## JOINT REGIONAL PLANNING PANEL (Sydney East Region)

<b>JRPP No</b>	2016SYE034
<b>DA Number</b>	DA-2016/276
<b>Local Government Area</b>	BAYSIDE
<b>Proposed Development</b>	Construction of a six (6) storey boarding house, comprising 38 boarding rooms including one manager's room, rooftop communal open space and ground level parking and demolition of existing structures.
<b>Street Address</b>	4 Innesdale Road, Wolli Creek
<b>Applicant/Owner</b>	VP1 Pty Ltd
<b>Number of Submissions</b>	Eight (8) submissions including one (1) petition with 46 signatures and 4 submissions from one household.
<b>Regional Development Criteria (Schedule 4A of the Act)</b>	'Affordable Housing' with a Capital Investment Value >\$5M.
<b>List of All Relevant s79C(1)(a) Matters</b>	<p>Relevant environmental planning instruments; s79C(1)(a)(i):</p> <ul style="list-style-type: none"> <li>• SEPP – Affordable Rental Housing</li> <li>• SEPP – State and Regional Development 2011</li> <li>• Rockdale Local Environmental Plan 2011</li> </ul> <p>Any proposed instrument that is or has been the subject of public consultation under the Act and that has been notified to the consent authority: s79C(1)(a)(ii);</p> <ul style

Figure 2 – Amended Rooftop Plan

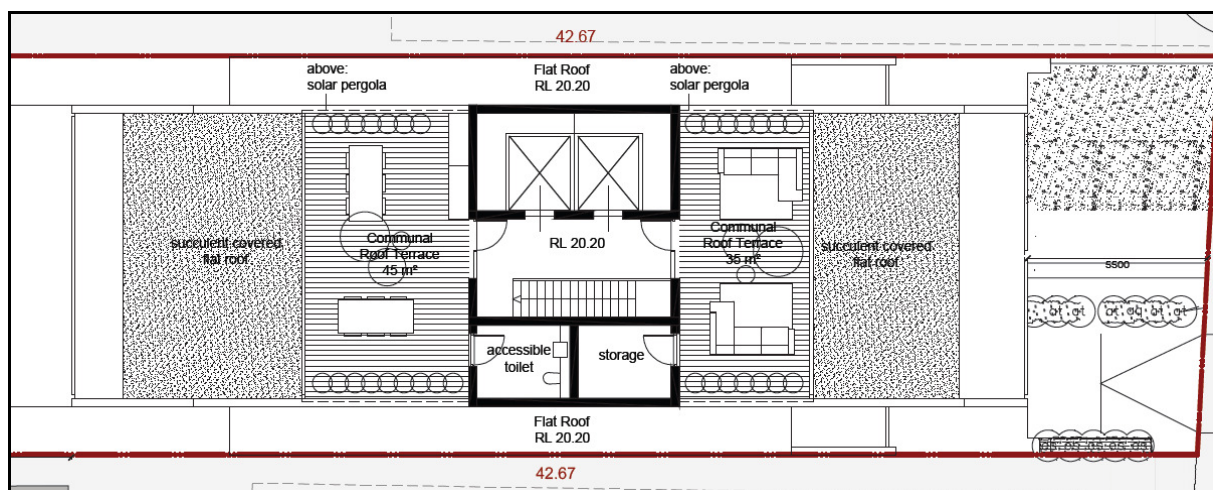
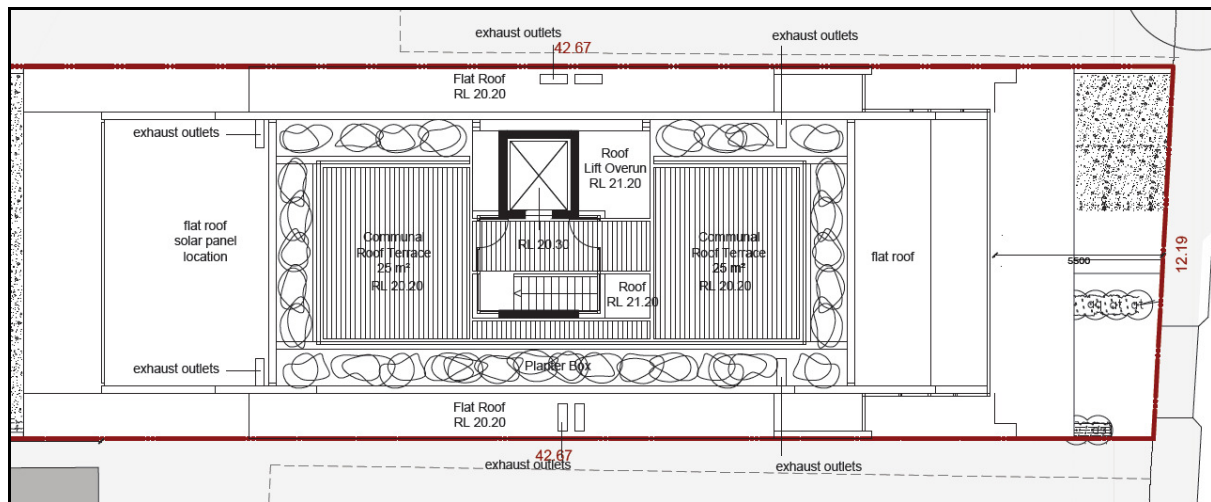
1. *Minimise the bulk of structures on the roof which breach the height control, remove enclosing structures and roof and replace by planter boxes for privacy, remove toilet, storage and one lift.*

Comment: As originally proposed the rooftop communal terrace as proposed incorporated two lift cores, stair overrun, lobby, storage room, toilet and pergola structures. This is illustrated below in Figure 1.

Amended plans as submitted by the applicant have removed and minimised rooftop, thus reducing the bulk and extent of any structures penetrating the height limit on site.

As can be seen below in Figure 2, only a single lift overrun extends to the rooftop level and the previously proposed enclosing structures including the pergolas, wind amelioration screens, toilet, store room and lobby area have been deleted.

Solar panels have been relocated to the roof level of the floor below and sit flush with this level as do exhaust outlets. Planter boxes, 1.1m high X 1.1m wide, have been introduced along the periphery of the communal roof top terrace and are proposed to be planted with Camellia Sasanquas, which comprise a mature height of 2 metres and will provide privacy to neighbouring properties and wind amelioration to future users of the terrace.

The proposed amendments illustrated above are deemed to satisfactorily address the concerns raised by the JRPP.

Figure 4 – Revised section AA

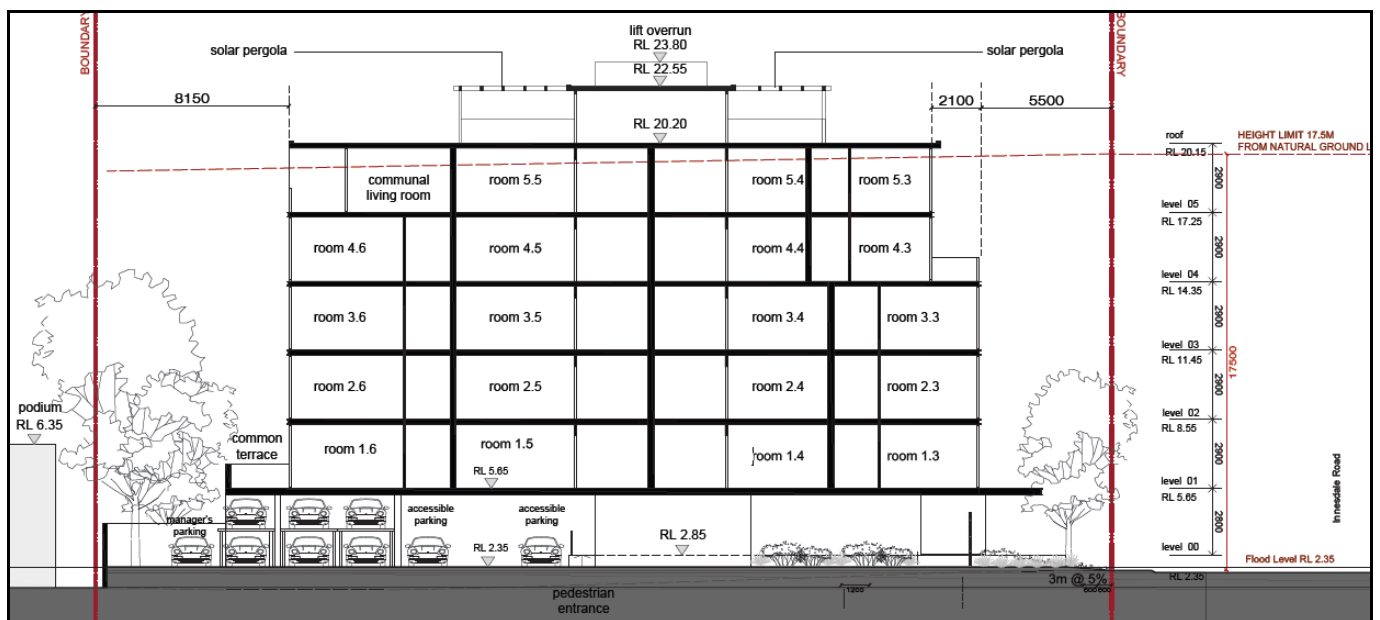
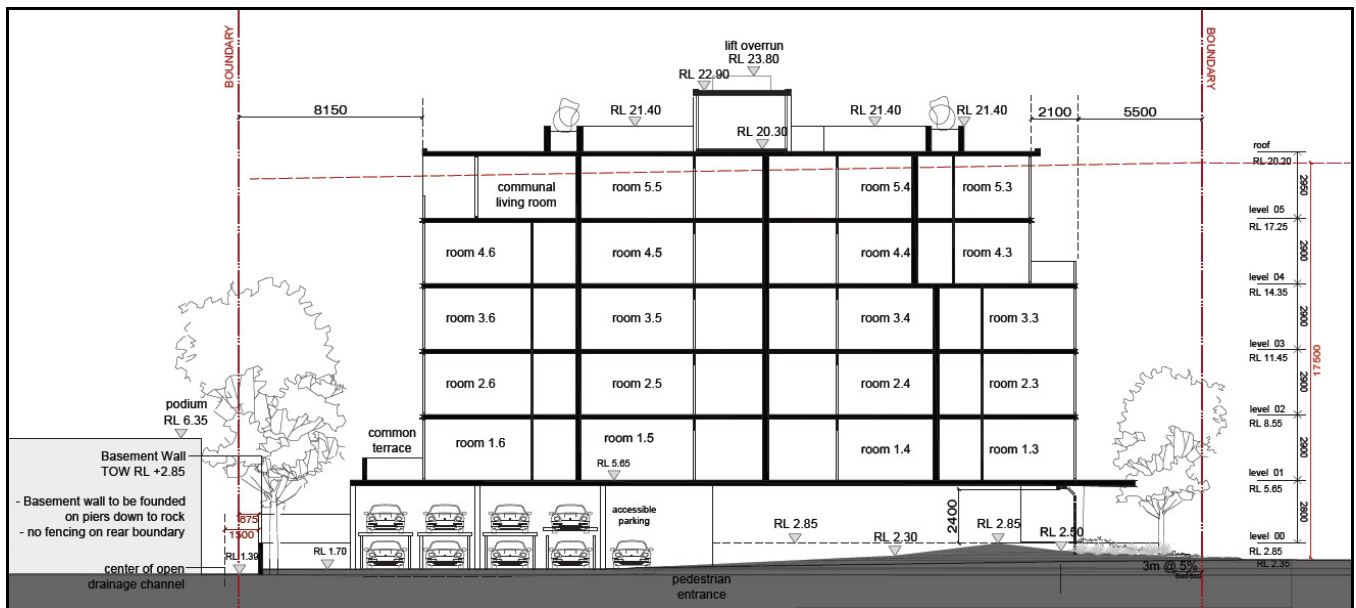
2. Demonstrate how the stacked parking will work, given that there is intended to be separate ownership of cars above each other in the stacked arrangement and there cannot be pits because of potential flooding. If the stacked parking does not work, how does the proposal meet the parking requirements of SEPP (Affordable Rental Housing) 2009.

Comment: As originally proposed, the ground level car parking area comprised a finished slab level of 2.35RL as illustrated in Figure 3 below in order to ensure appropriate clearance was provided to avoid any potential future flood affectation. Details in regards to car stackers were not clarified within the JRPP report and concerns were raised in regards to their implementation and practicality of use on site. The aforementioned has been clarified below.

Amended plans as submitted by the applicant depict minor changes to the ground floor level of the development, in order to enable a crest level of 2.85RL to avoid potential flood waters entering the site and to further enable sufficient head room for the proposed car stackers.

Council's Engineer has reviewed the chosen car stacker system and confirmed that appropriate headroom and aisle width is provided for the proposed stackers on site. Further that the proposed finished level of the ground floor car parking area is satisfactory in relation to flooding constraints on site.

Figure 5 – Evolution Parking System

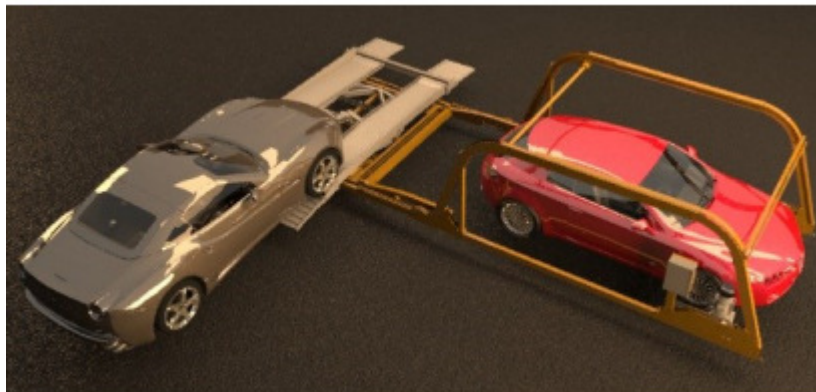
The type of stackers chosen are called the 'Evolution Parking System'. These stackers enable the top vehicle to be driven straight onto a rotating platform, raised and parked above a vehicle at ground level. To exit the stacker system, the vehicle is lowered by a mechanical arm and rotated on the rotating platform, to enable forward entry and exit on site.

*Figure 6 – Room section*

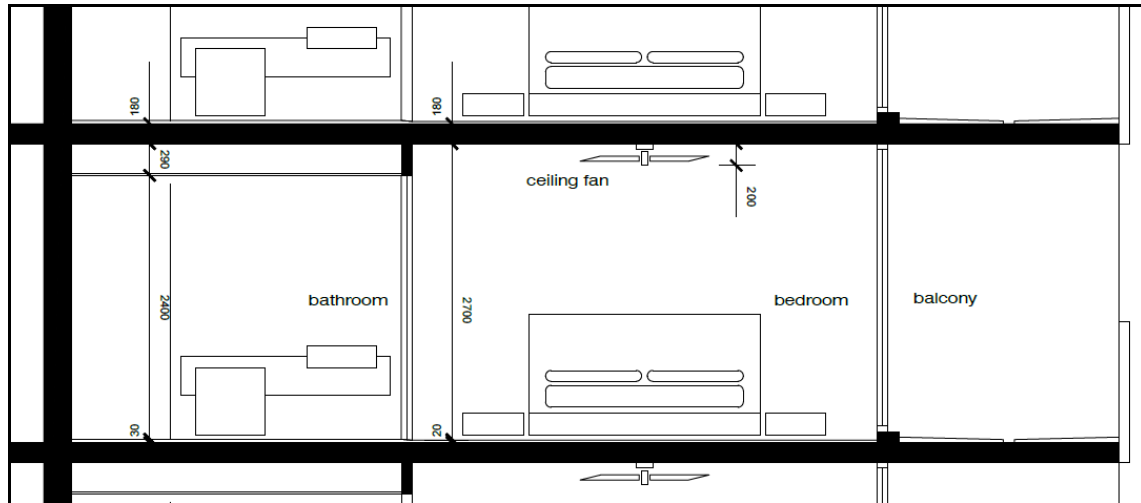
3. Demonstrate by sketch how the services will be conducted in the bulk heads, given that the floor to floor height is only 2.9m and cannot be increased without additional breaches of the height control which the Panel would not accept.

Comment: As noted by the JRPP, clarification, including sketches for the proposed 2.9m floor to floor height were requested in order to ensure appropriate amenity is achieved within the constructed development.

Given the above, the following calculations are provided for habitable / non habitable areas for a proposed 2.9m floor to floor level.

#### Habitable

- 180mm R.C Slab
- 20mm Carpet and Underlay, or direct glue-fixed floor tiles

- No False Ceiling (bathroom exhaust duct concealed within top of cupboards or vented to main building services ducts)
- 2700mm ceiling height

*Non Habitable*

- 180mm R.C Slab
- 30mm Tile floor
- 2400mm ceiling height
- 290mm false ceiling cavity concealing plumbing to stacked bathrooms above.

The above specifications illustrate that a 2.9m floor to floor level is achievable, with acoustic amenity to comply with the requirements of the BCA.

Given the above specifications, bulk heads are not required and no further height increase is required to accommodate the development.

Figure 7 – Motorbike and Bicycle Parking Locations

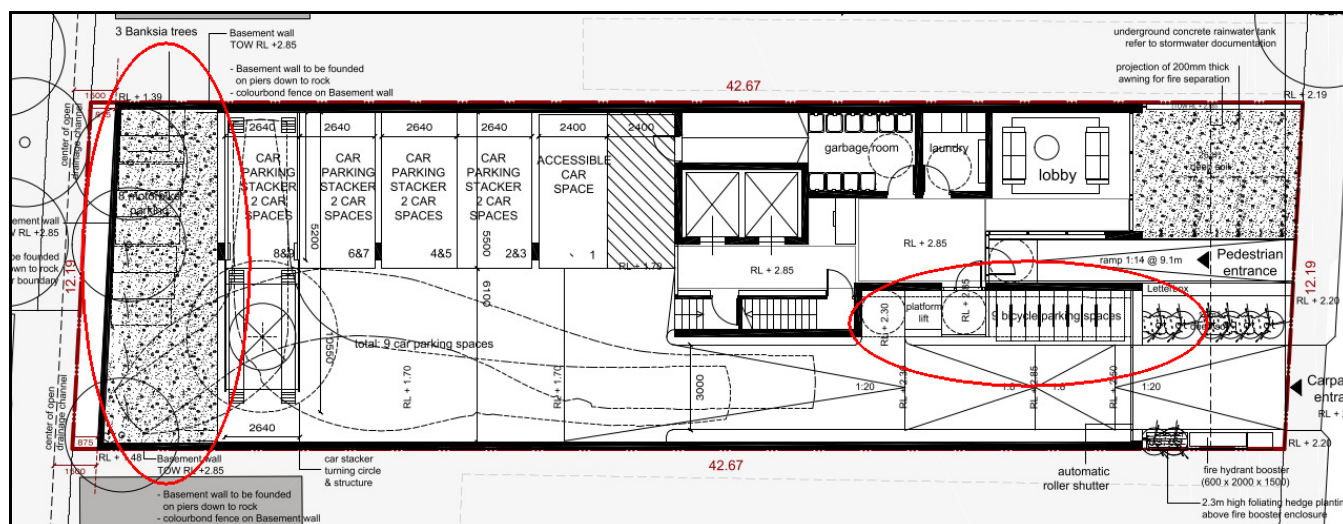
5. Demonstrate that the proposal has adequate parking for bicycles and motorcycles to comply with the SEPP (Affordable Rental Housing) 2009.

Comment: Amended plans illustrate the location of eight motorbike spaces within the rear of the site upon a grass-crete area. Eight bicycle spaces within the driveway of the proposed development. These spaces are appropriately dimensioned and are confirmed to be satisfactory by Councils Engineer.

The proposal thus complies with the provisions of SEPP – ARH 2009 in this regard.

Figure 8 – Location of fixed opaque cladding

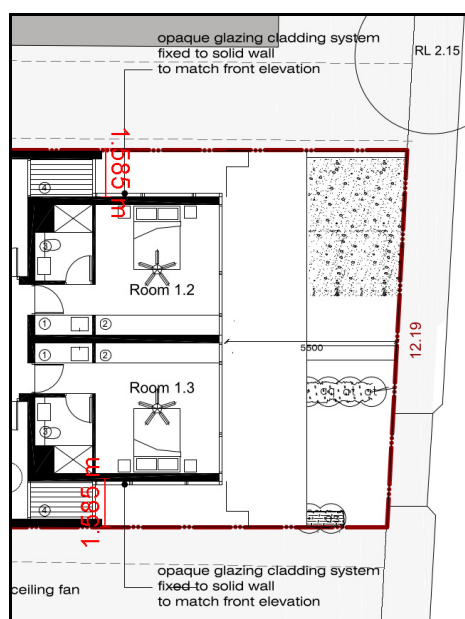
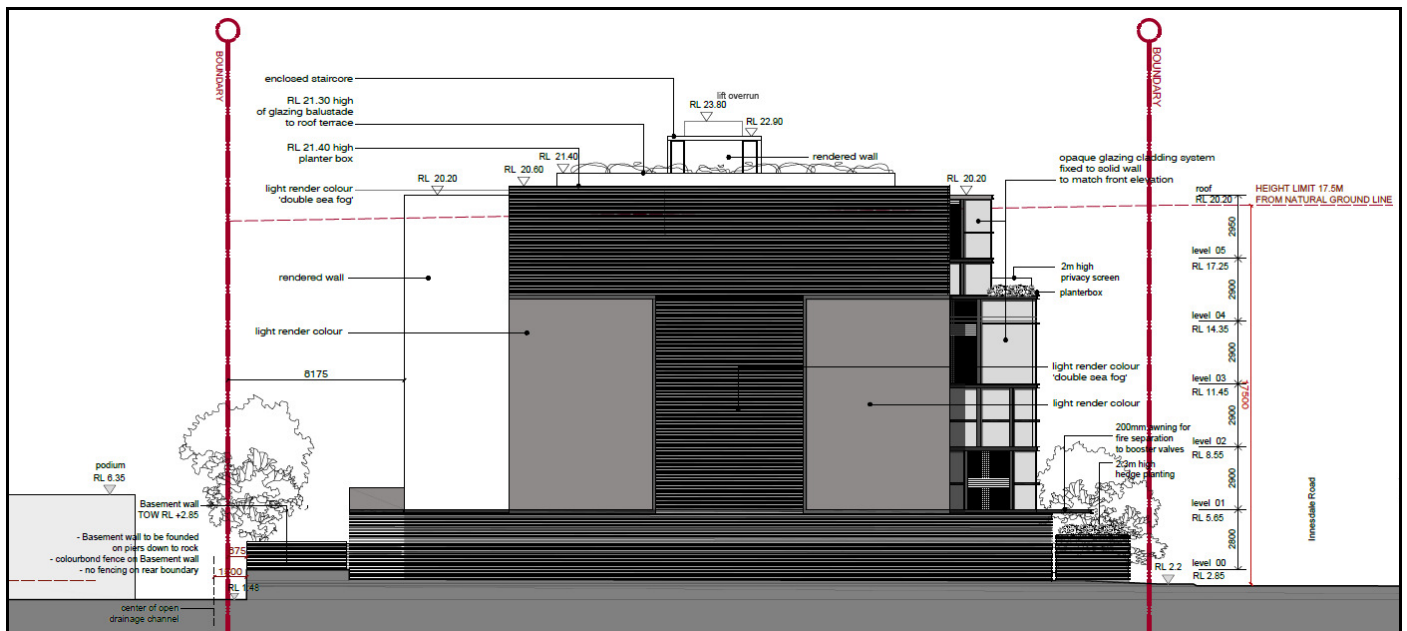
6. Check for inconsistencies between the plans and elevations and resolve such inconsistencies to the satisfaction of the assessment officer. There should be no openings or translucent materials on the boundary.

Comment: Amended plans have resolved inconsistencies between floor plans and elevations. Revised elevations confirm that there are nil openings and / or translucent materials located at common side boundaries.

An opaque glazing cladding system is proposed to be fixed to solid walls at the eastern and western sides of boarding rooms fronting Innesdale Road. These boarding rooms are setback a minimum of 1.585m from common side boundaries as illustrated in Figure 8 below which depicts level 1.

The proposal is satisfactory in this regard and solid party walls are proposed at common side boundaries.

*Figure 11 - Recessed upper levels / 20-26 Innesdale Road Wolli Creek*

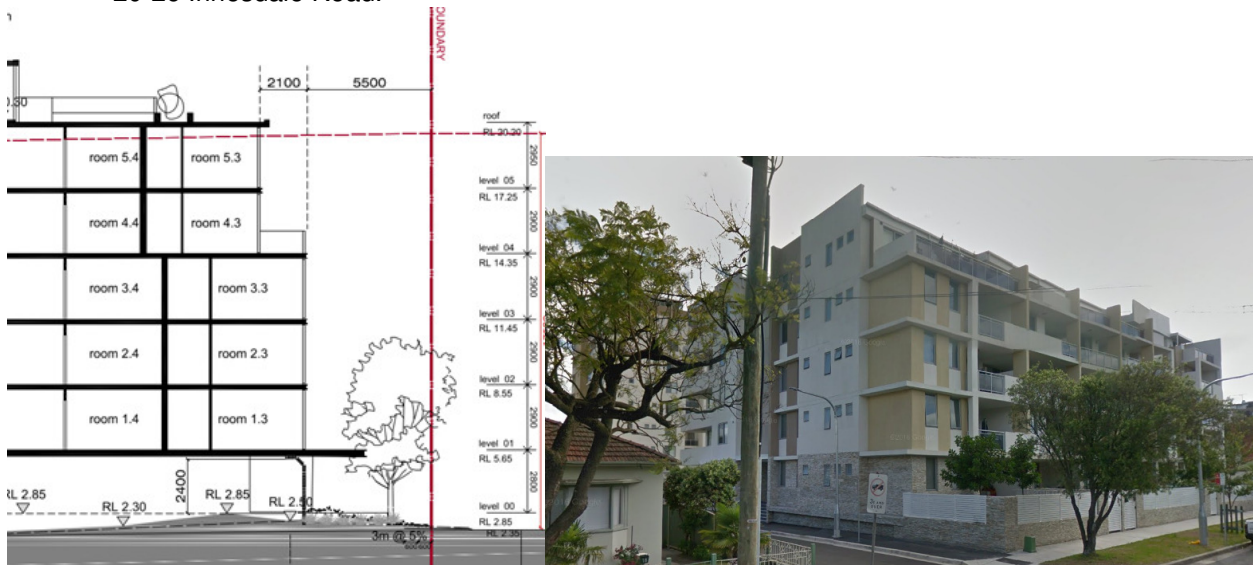
7. *The extent to which the proposal meets the requirements of Clause 30A of SEPP (Affordable Rental Housing) 2009, which relates to consistency with the character of the area, specifically in relation to building on the side boundaries.*

As noted within the report to the JRPP, the proposal has been designed to present as a 4 storey building to Innesdale Road, with levels 5 / 6 and the rooftop communal open space area recessed further into the site from lower levels. Recessing the upper levels of the development minimises the bulk, height and scale of the development when viewed from Innesdale Road and allows the

proposal to provide a sympathetic built form response to the low density residential nature of dwellings on the southern side of Innesdale Road. As can be seen below in Figure 11, a 7.6m front setback is proposed to levels 5 and 6, with a 5.5m front setback to lower levels. This is not inconsistent with the established setbacks of the existing residential flat building further to the east at 20-26 Innesdale Road.

Given the zoning of the subject site, existing and emerging context, the massing, height, scale, built form, setbacks and design of the proposed development are considered to be satisfactory with regards to the existing and future desired character of the area.
